HARTZELL PROPELLER INC.
SERVICE BULLETIN
TRANSMITTAL SHEET
HC-SB-61-392

108298 Cylinder Bushing and 108346 Hub Bushing

July 07, 2021

This page transmits a revision to Service Bulletin HC-SB-61-392.

**108298 Cylinder Bushing
Figure 1**

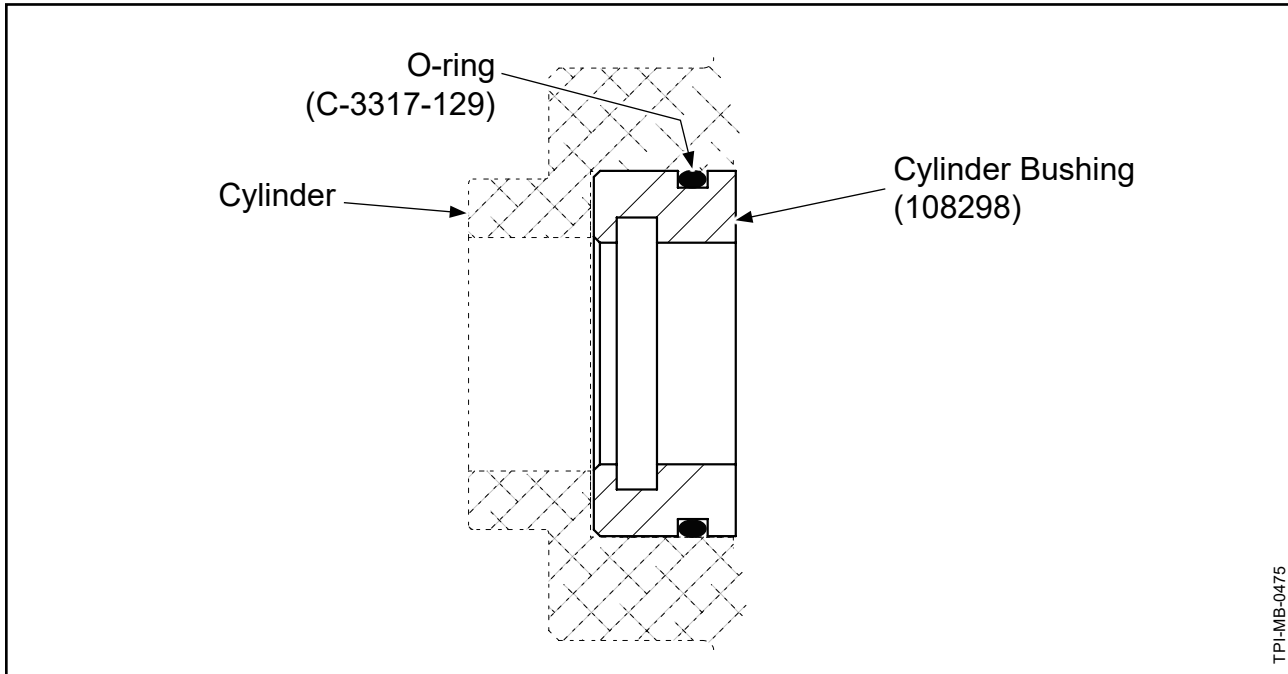
- (1) Hartzell Propeller Inc. has received reports of oil leaking at the A-3784 cylinder bushing on affected propellers.
 - (a) Hartzell is introducing the 108298 cylinder bushing as a replacement for the A-3784 cylinder bushing on affected propellers.
 - 1 The 108298 cylinder bushing has a machined O-ring groove on the OD of the bushing. This provides a more consistent seal between the bushing and the cylinder to prevent oil leaks. Refer to Figure 1.

**108346 Hub Bushing
Figure 2**

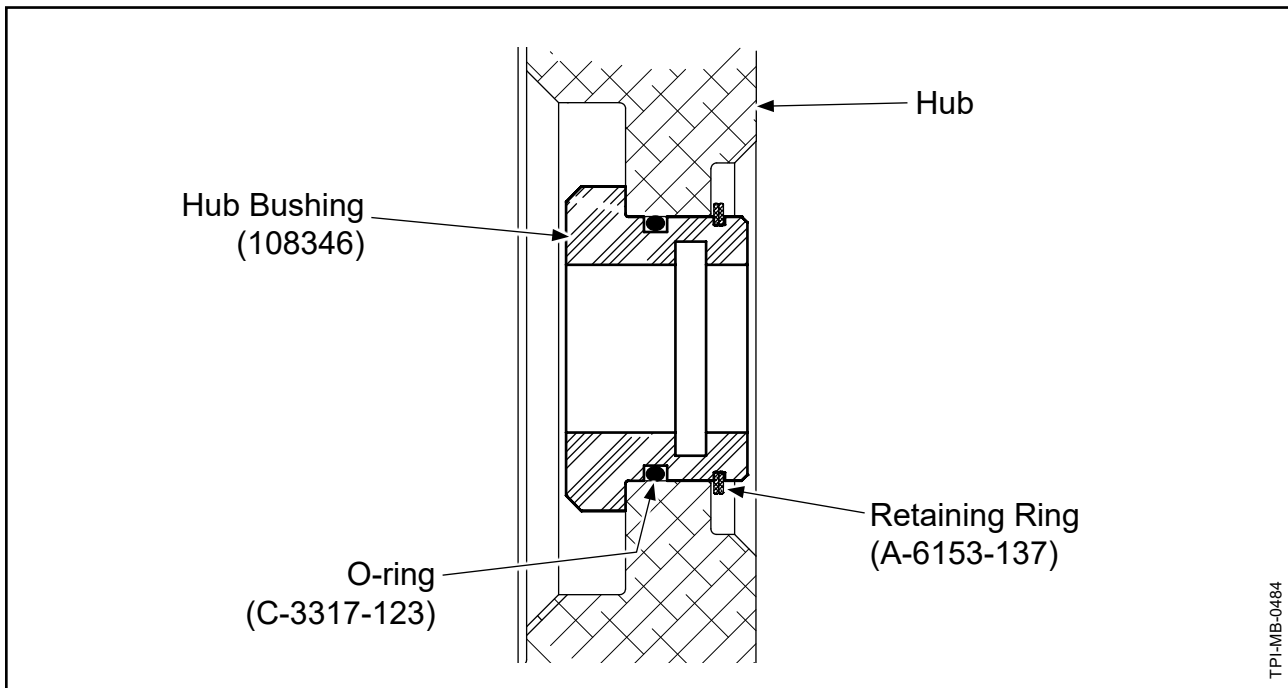
- (2) Hartzell Propeller Inc. has received reports of oil leaking at the hub bushing [p/n 104903 or A-3789()] on affected propellers.
 - (a) Hartzell is introducing the 108346 hub bushing as a replacement for the 104903 and A-3789() hub bushings on affected propellers.
 - 1 The 108346 hub bushing has a larger O-ring groove on the OD of the bushing.
 - 2 The larger O-ring (p/n C-3317-123) used with the 108346 hub bushing provides a more consistent seal between the bushing and the hub to prevent oil leaks. Refer to Figure 2.

Cylinder Inspection: Surface "J"
Figure 3

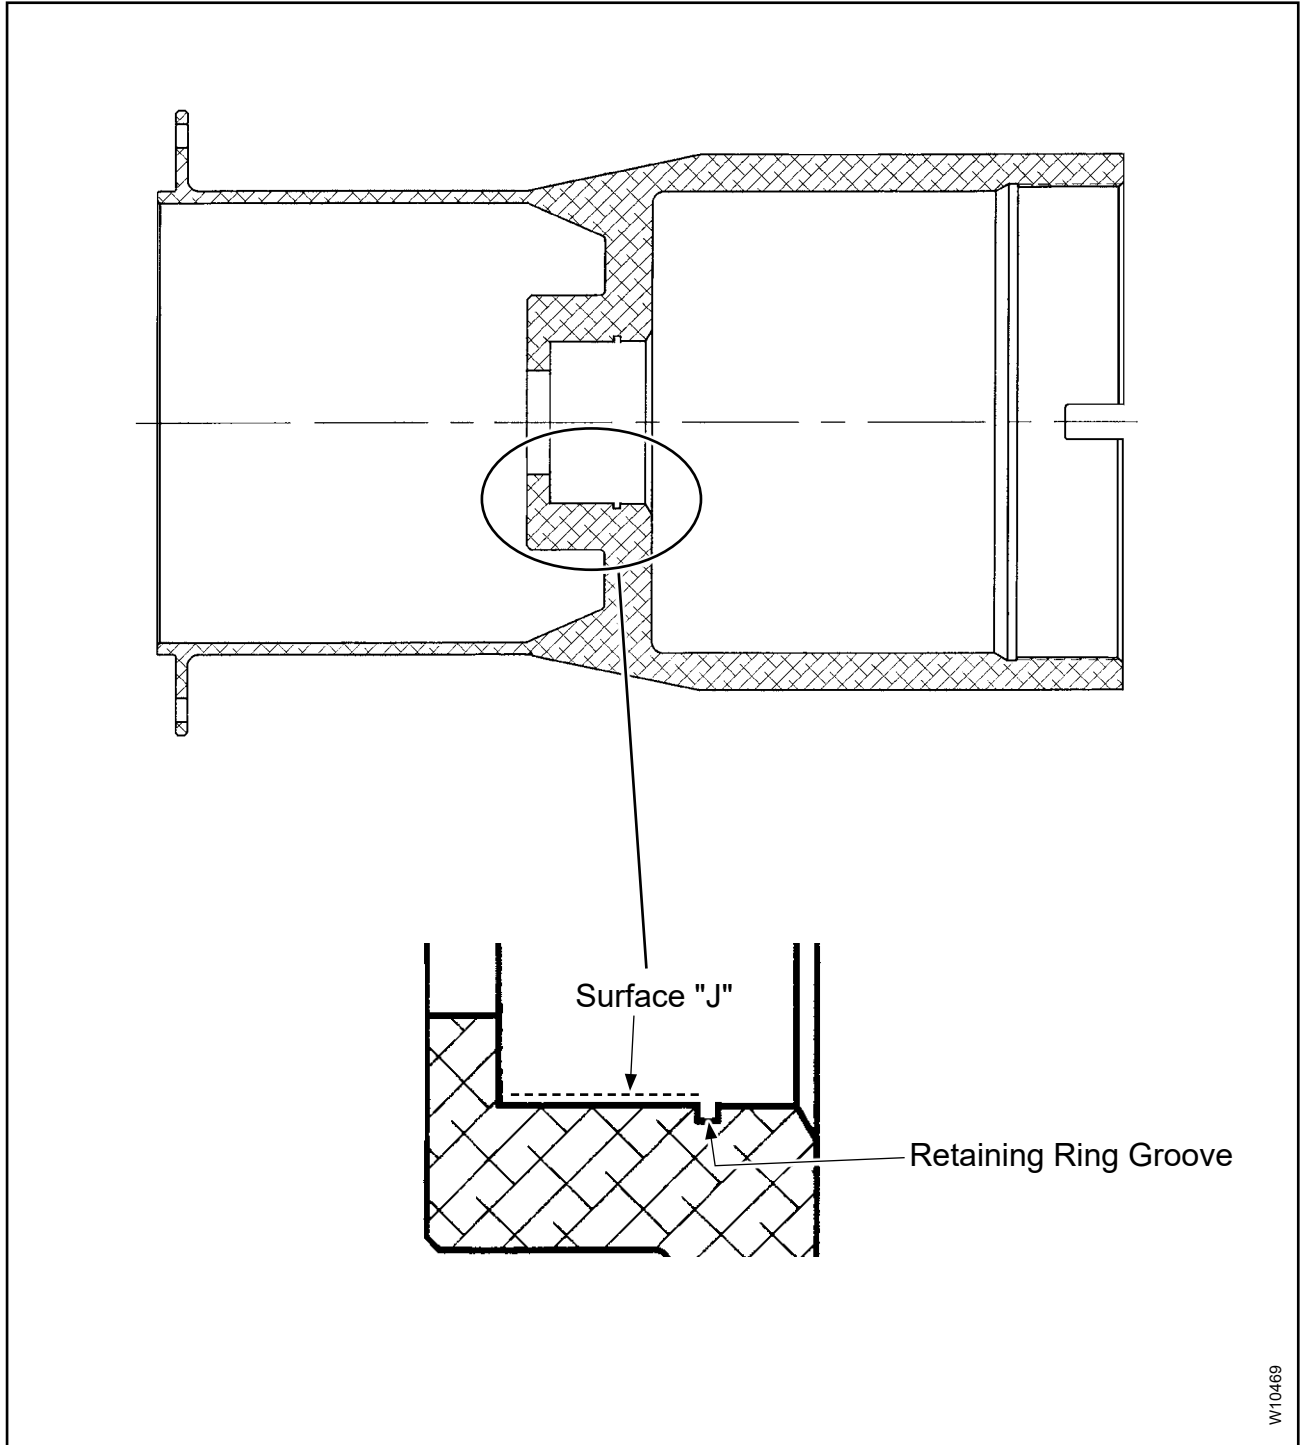
- (1) Inspect the cylinder in the affected propeller in accordance with the Check chapter of the applicable Hartzell Propeller Inc. overhaul manual, **except:**
 - (a) Inspect Surface "J" of the cylinder in accordance with Table 1 and Figure 3 in this Service Bulletin.

Inspect	Serviceable Limits	Corrective Action
<u>CYLINDER (Surface "J")</u> (Refer to Figure 3)		
(1) Using a Profilometer TE436-2 or equivalent, examine the finish on Surface "J".	The maximum permitted surface finish is 32Ra.	If the surface finish is greater than the permitted serviceable limits, polish Surface "J" using 3M microfinishing film (373L), or equivalent. The maximum permitted diameter of Surface "J" after repair is 1.7560 inch (44.602 mm).

Cylinder Leak Check Procedure
Figure 6

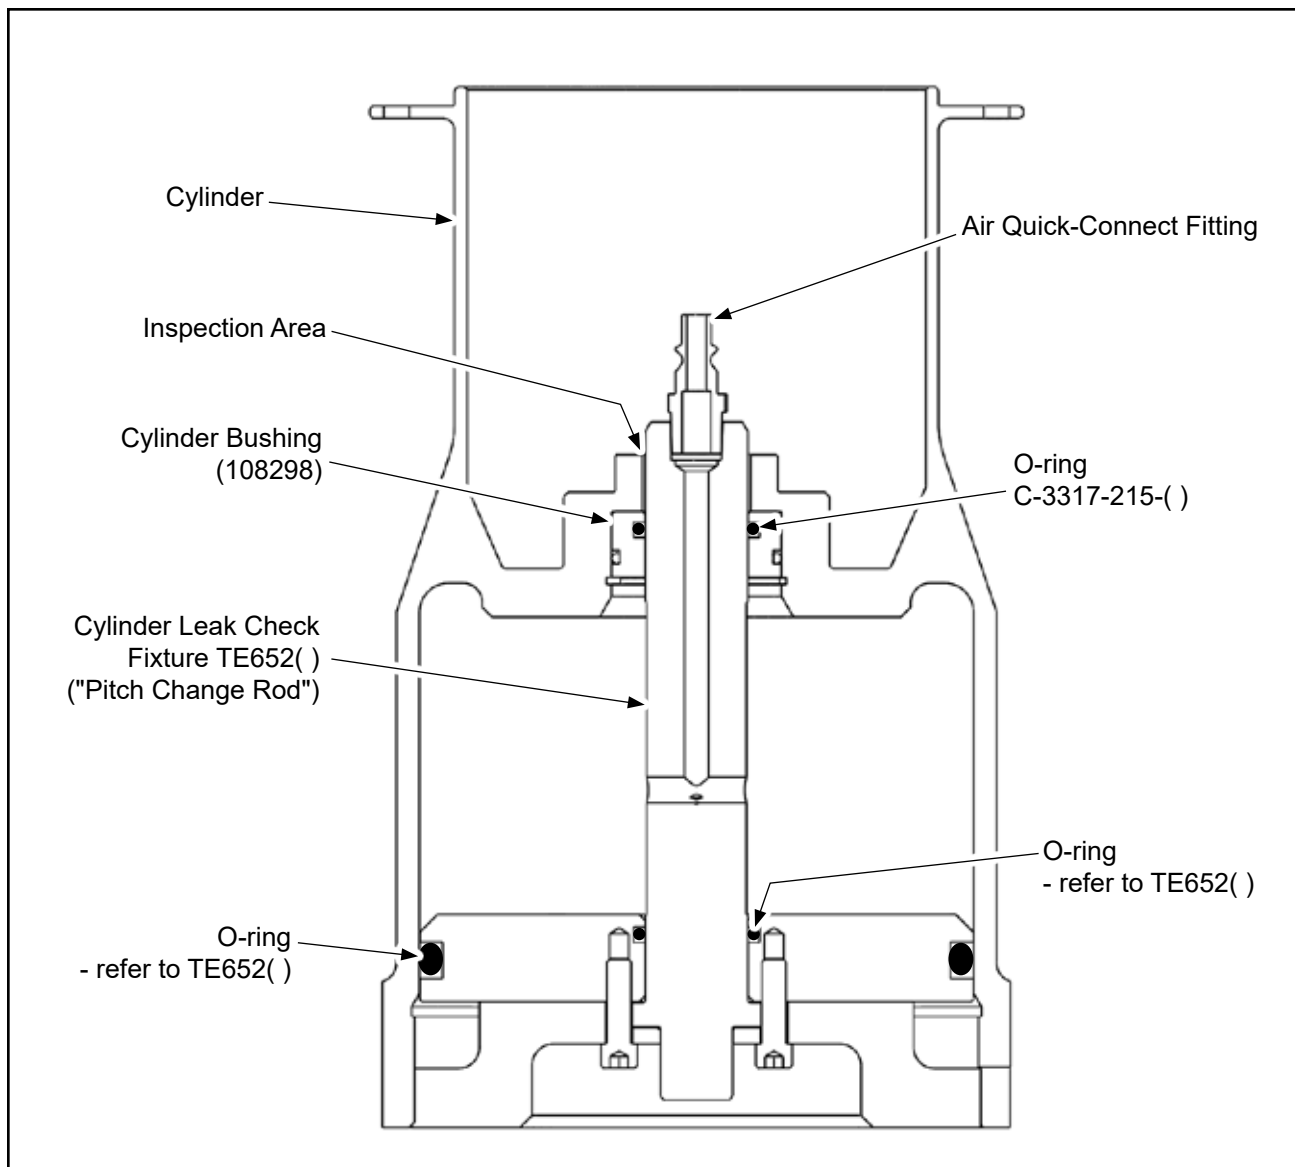
D. Cylinder Leak Check Procedure (Refer to Figure 6)

- (6) Check for leaks in the inspection area identified in Figure 6.
- (a) Apply leak detector CM122 to the inside of the cylinder where the "pitch change rod" of the cylinder leak check fixture TE652() contacts the cylinder.

Hub Modification
Figure 9, page 1 of 2

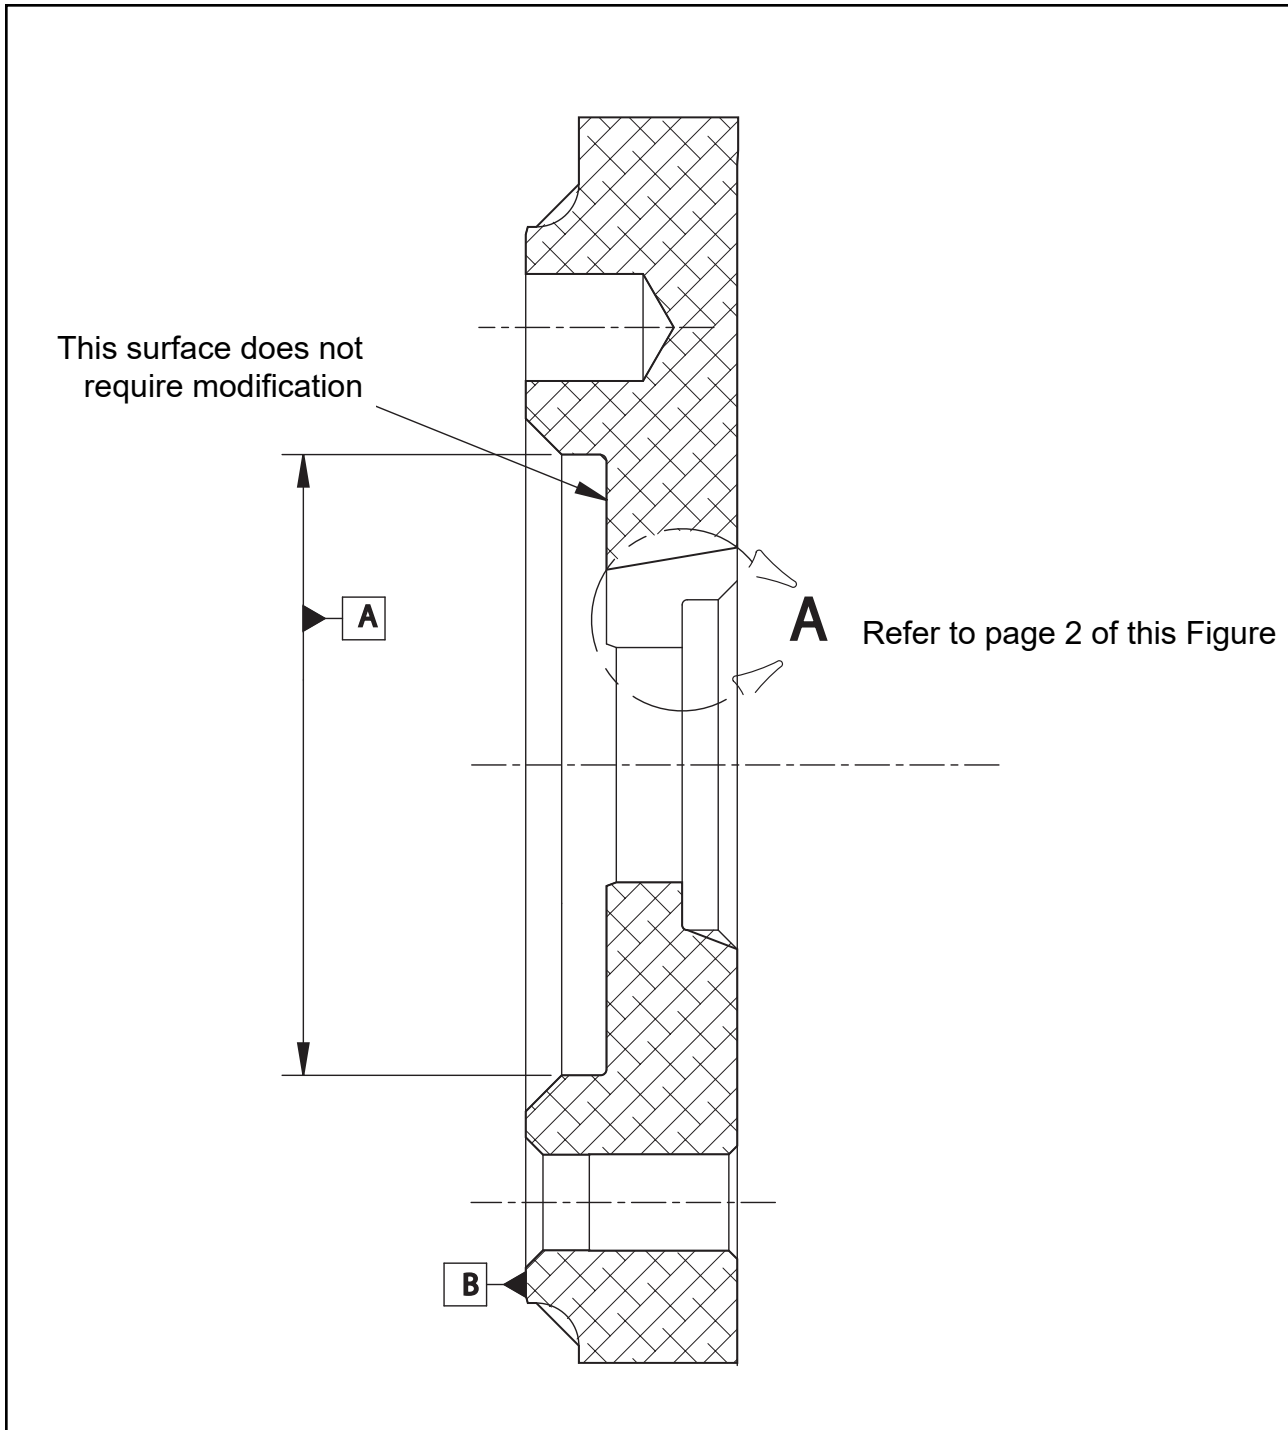
- (1) Remove the bonded A-3789() hub bushing in accordance with the applicable instructions in the Aluminum Hub Overhaul chapter of Hartzell Propeller Inc. Standard Practices Manual 202A (61-01-02).
- (2) Machine the propeller hub in accordance with Figure 9.
 - (a) Remove any burrs.
 - (b) Machined surfaces must have a surface finish of at least 63 micro inches (1.6 micro meters).
 - (c) Apply chemical conversion coating to the machined area in accordance with the Chromic Acid Anodizing chapter of Hartzell Propeller Inc. Standard Practices Manual 202A (61-01-02).
